March 27, 2015

Re: VCP # 13CVCP155K
E-Designation # 13EHAZ341K
50 Greenpoint Avenue, Brooklyn, NY
Remedial Action Work Plan (RAWP) Stipulation List

GRANT engineering hereby submits a Remedial Action Plan (RAWP) Stipulation List for the Site to the New York City Office of Environmental Remediation (OER) on behalf of Pine Builders. This letter serves as an addendum to the RAWP to stipulate additional content, requirements, and procedures that will be followed during the site remediation. The contents of this list are added to the RAWP and will supersede the content in the RAWP where there is a conflict in purpose or intent. The additional requirements/procedures include the following Stipulation List below:

DRAWING TITLE
END POINT SAMPLING PLAN

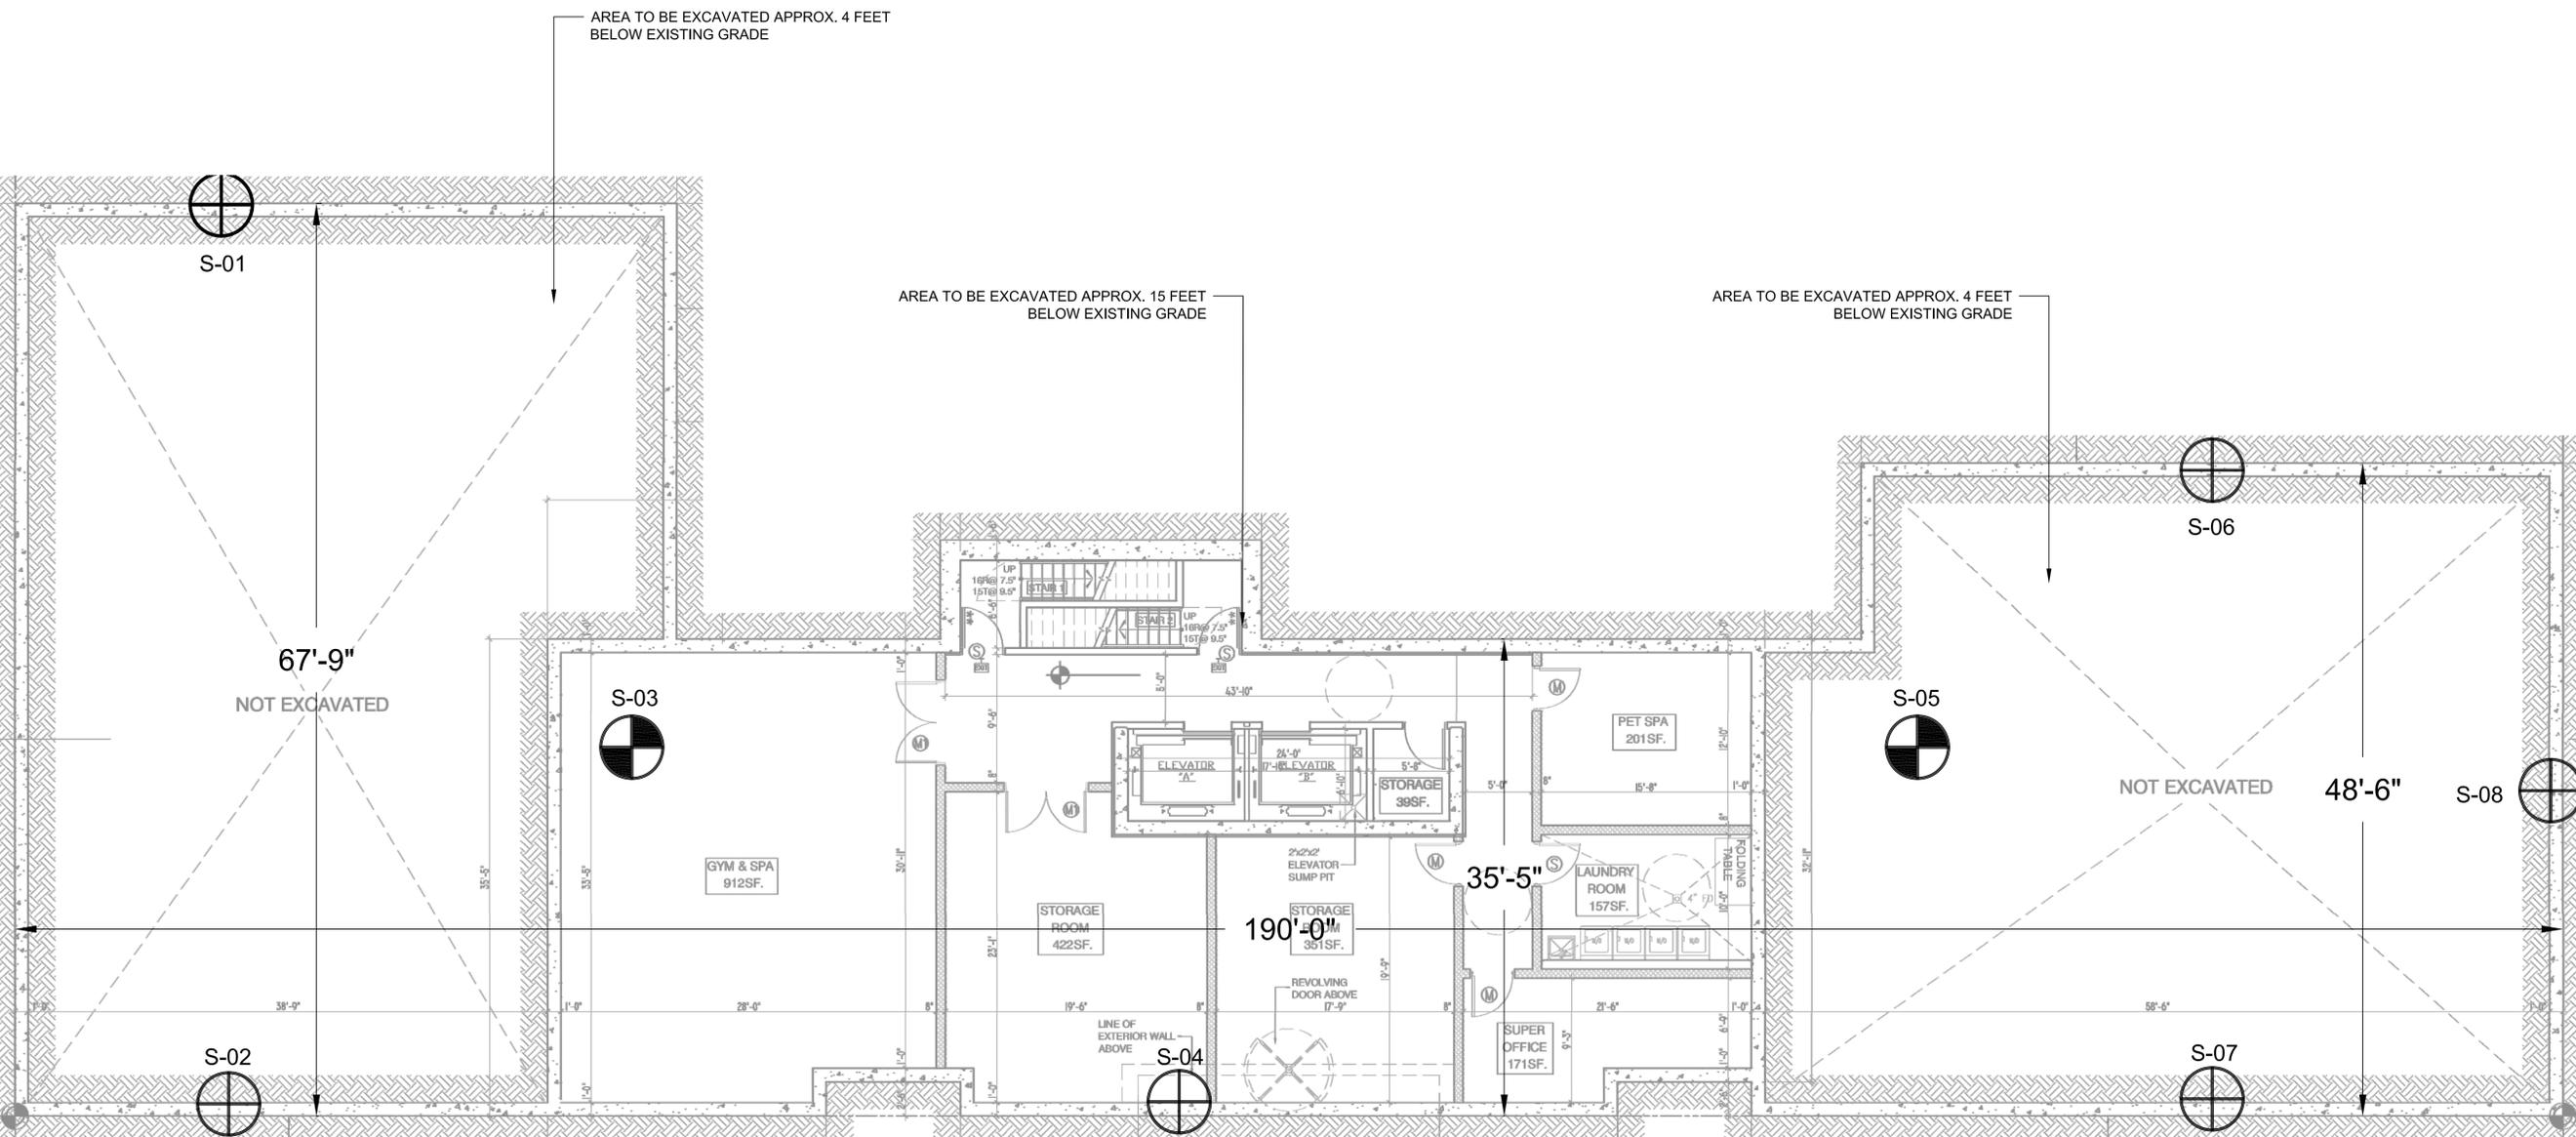
7. Collection and analysis of 5 end-point samples from the bottom of the excavation will be collected to evaluate the performance of the remedy with respect to attainment of Track 4 SCOs. A map indicating end-point sampling locations is attached in **Appendix 4**. Samples will be analyzed for contaminants of concern VOCs, SVOCs, Metals, PCBs, and Pesticides.

DRAWING TITLE
SSDS INSTALLATION PLAN

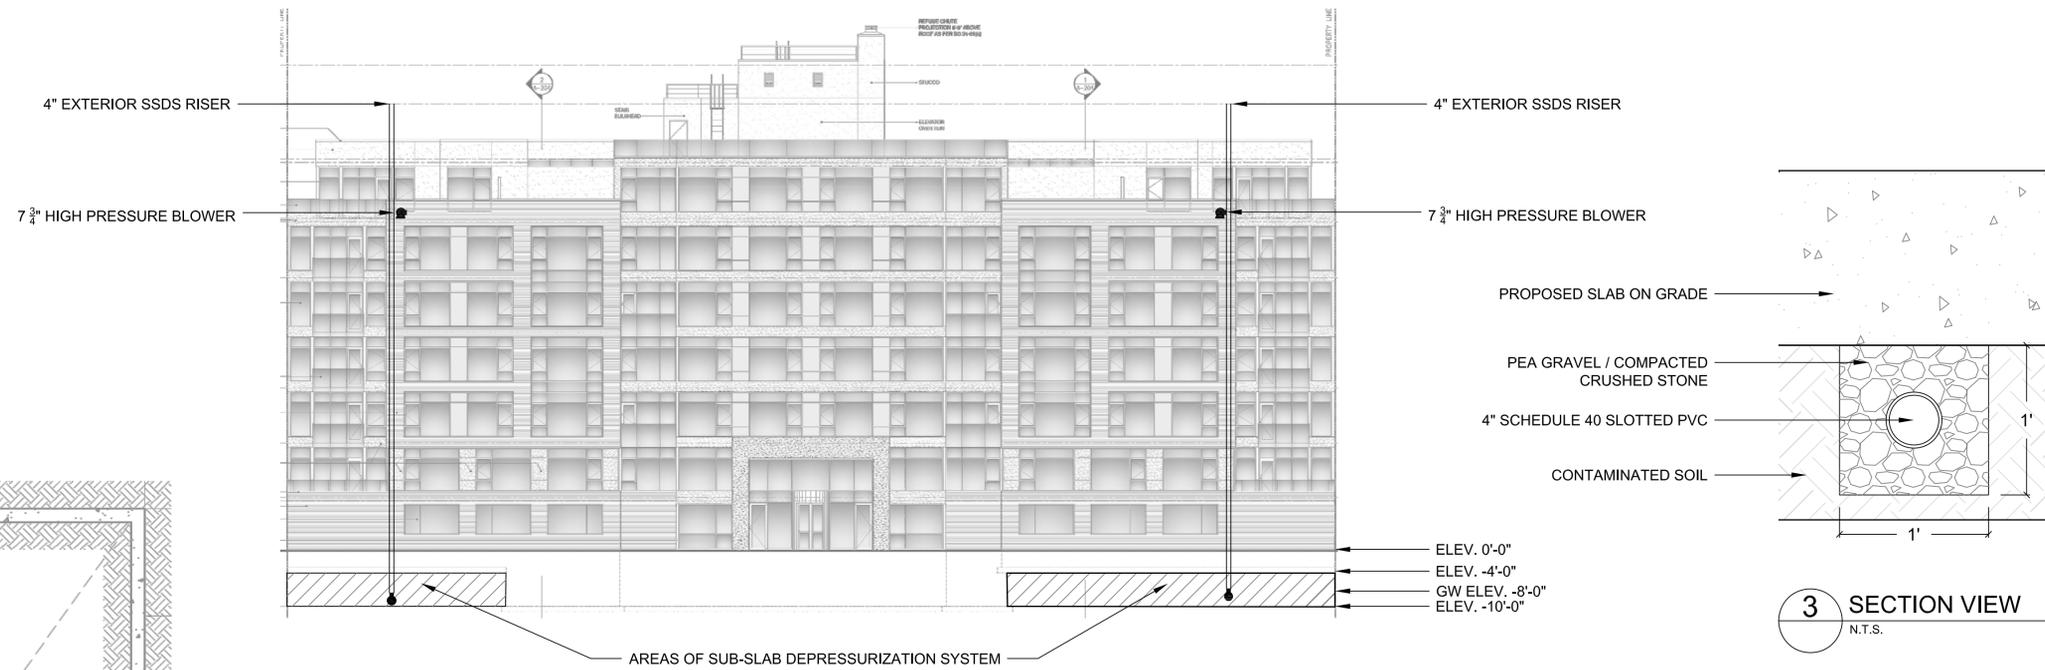
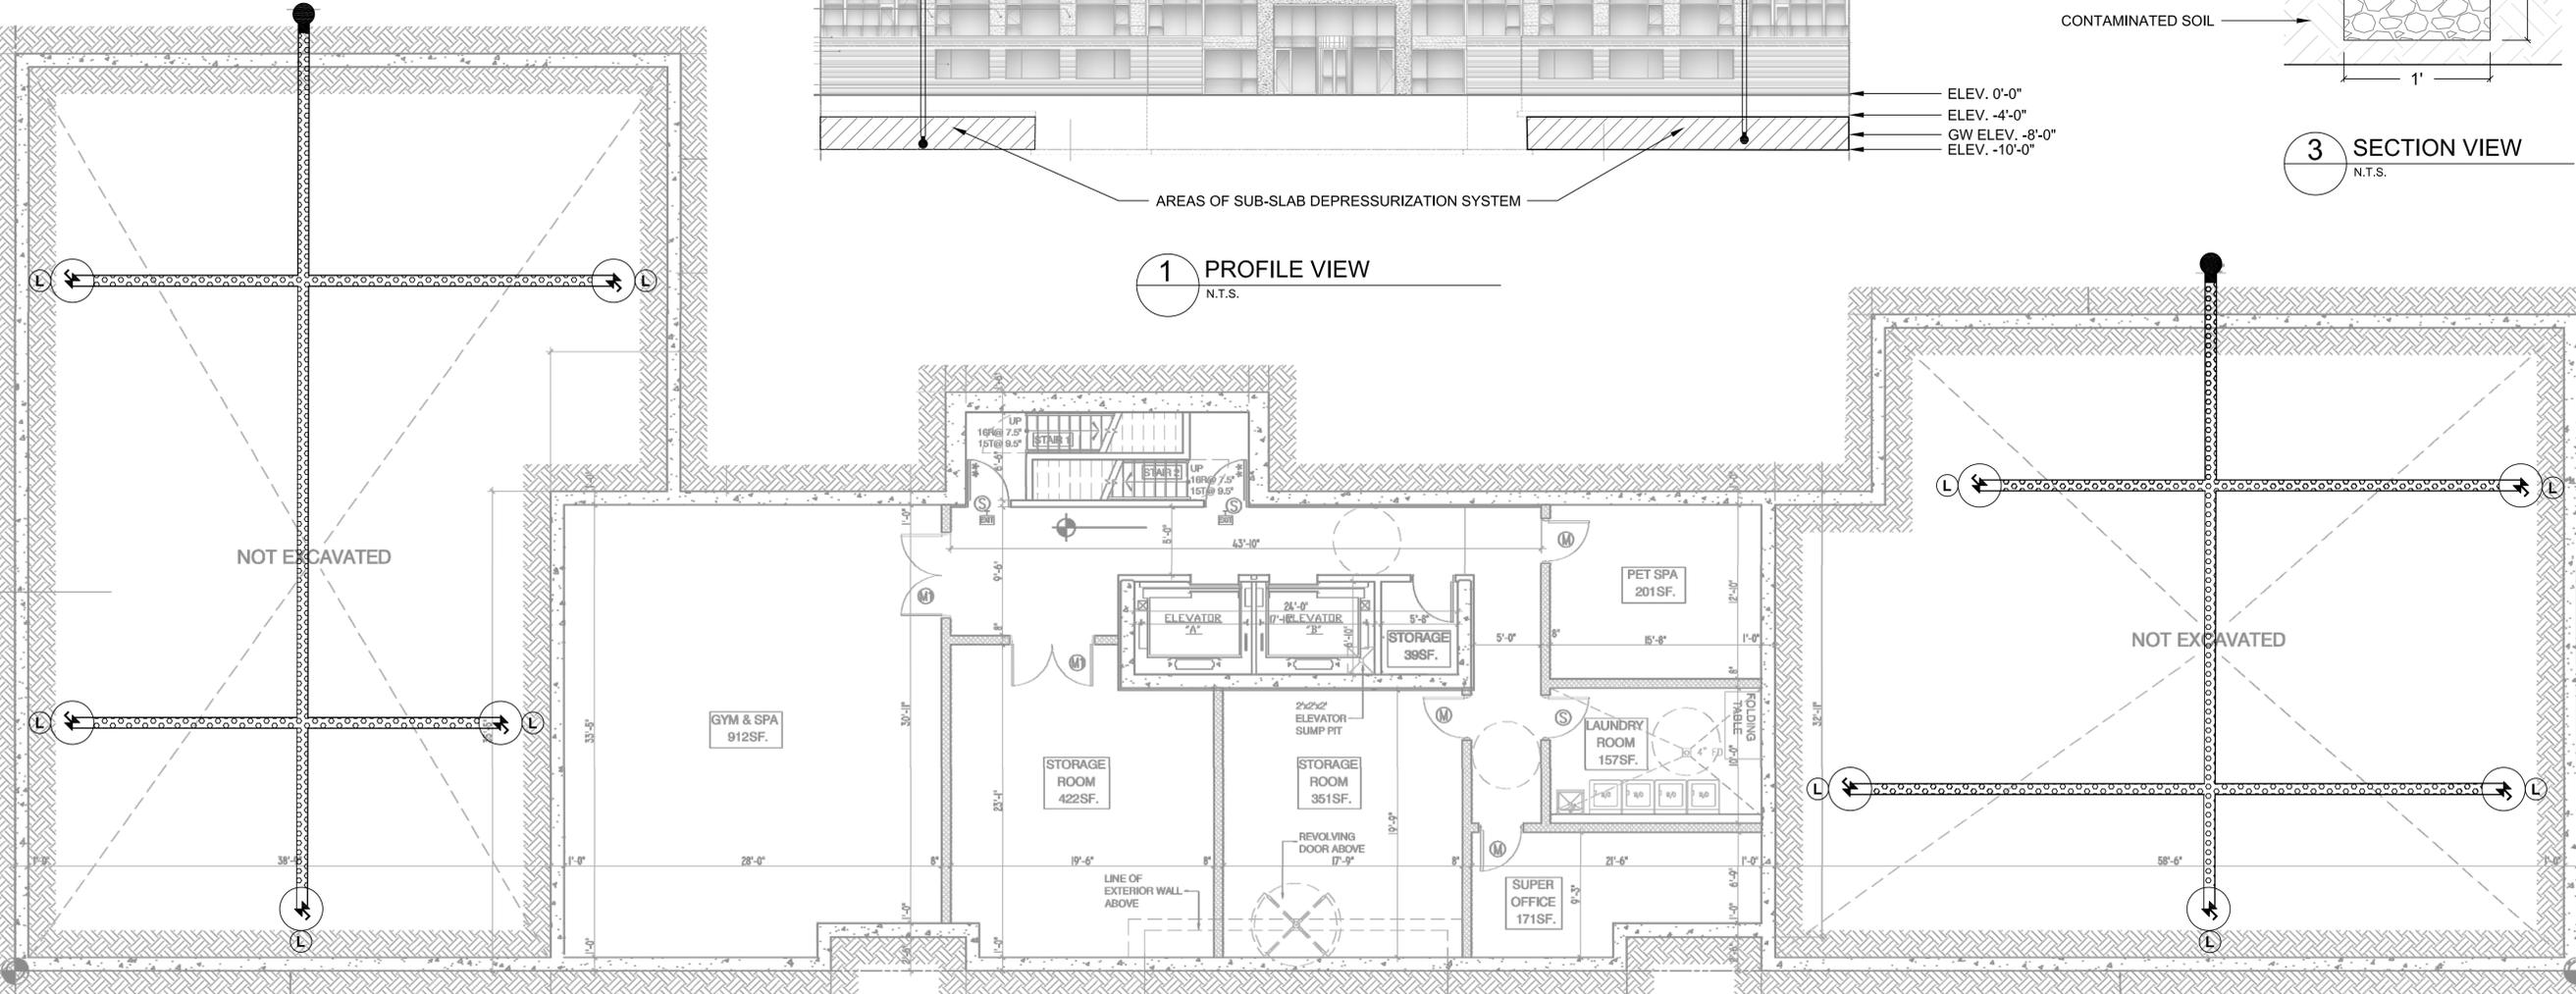
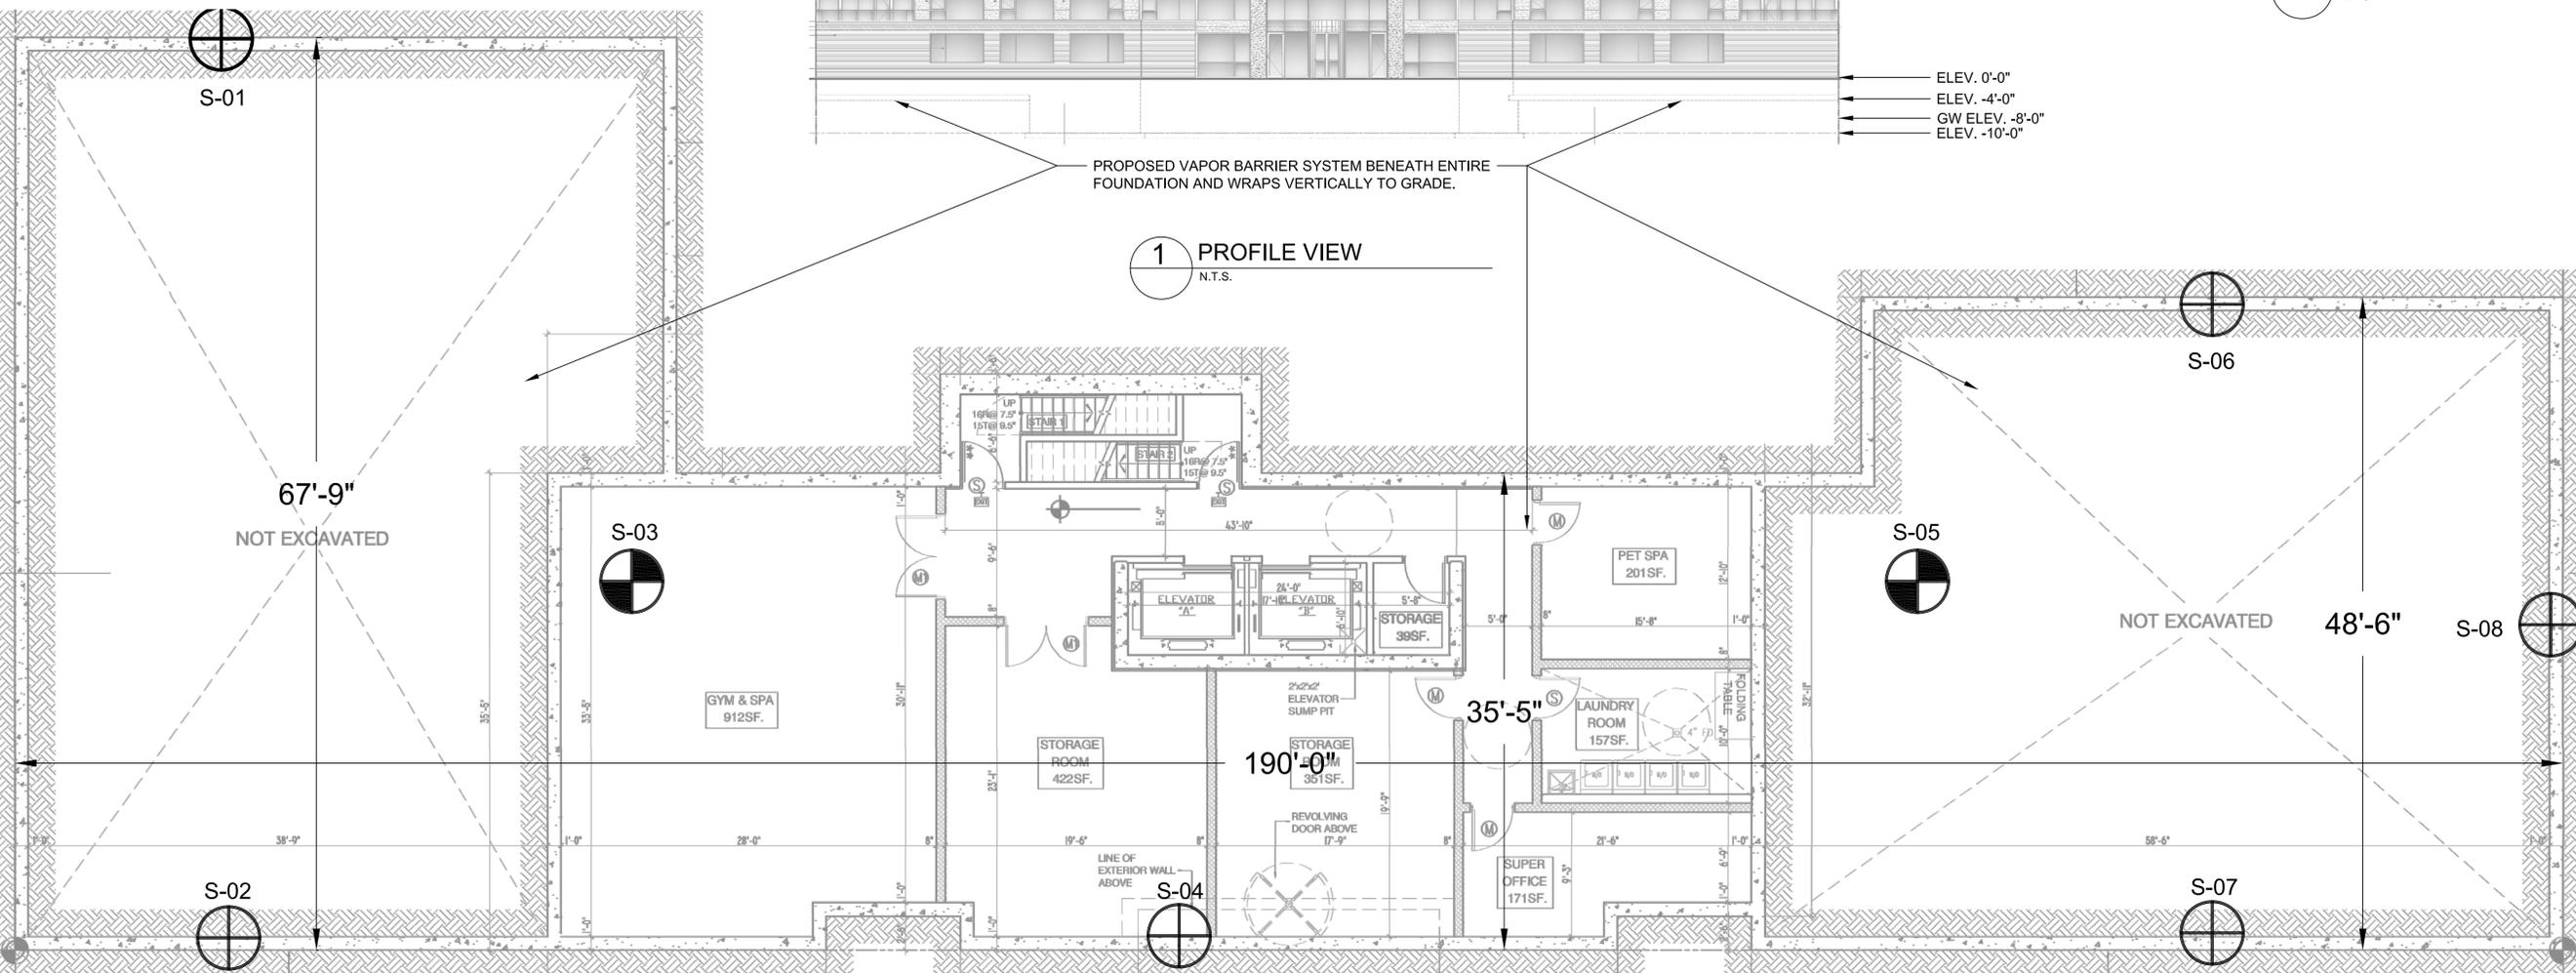
- 11. **Appendix 8** includes design plans for an active Sub-Slab Depressurization System (SSDS) that will be installed beneath the foundation of the proposed slab on grade portion of the building. This area will be excavated to approximately 4 feet below grade. An SSDS will not be installed beneath the basement of the proposed building since excavation will occur to depths between 10 to 15 feet below grade. The groundwater table is present at depths of approximately 8 to 11 feet below grade and an SSDS beneath the basement will not effective if installed within groundwater;
